March 6 2003

**component side**

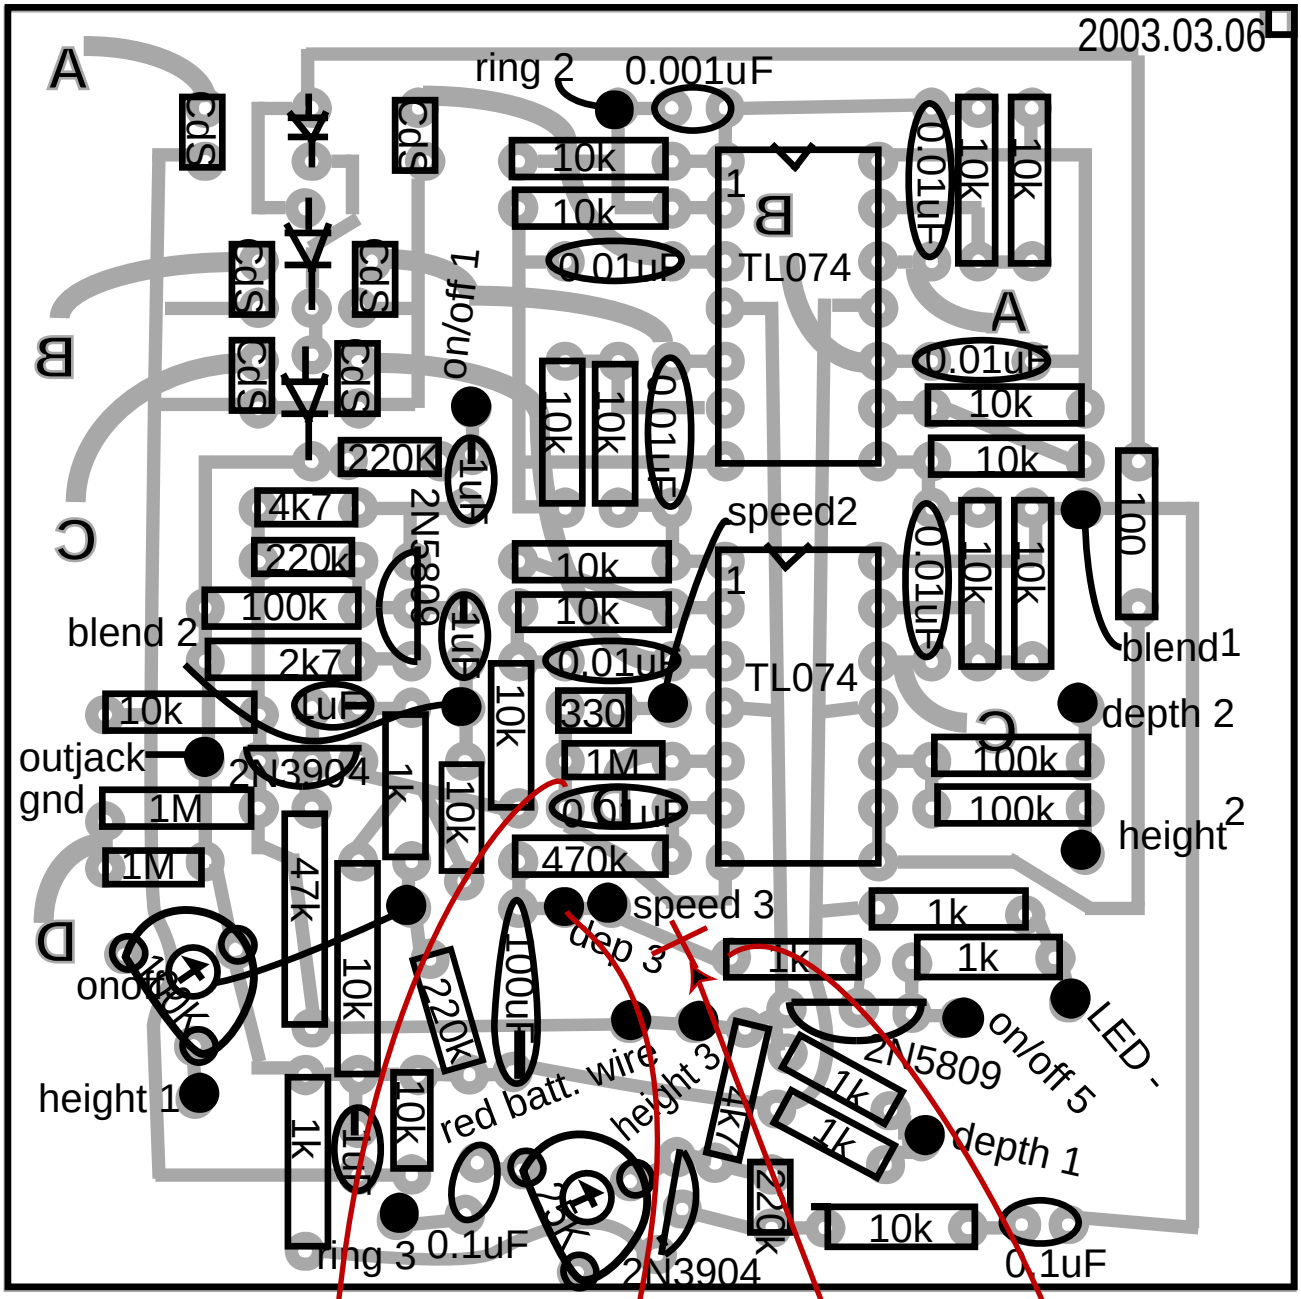
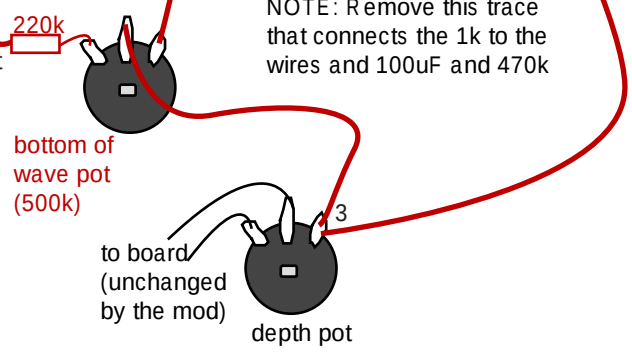
In summary:
1) Remove existing wire from "depth 3" on board to the pot
2) Snip/remove the indicated trace between the 1k and the 100uF/470k/wires
3) Solder a wire from "depth 3" on the board to Wave 3
4) Solder a wire from the indicated spot on the board through a 220k resistor to Wave 1
5) Solder a wire from Wave 2 to lug 3 on the depth pot
6) Solder a wire from lug 3 on the depth pot to the 1k resistor on the board
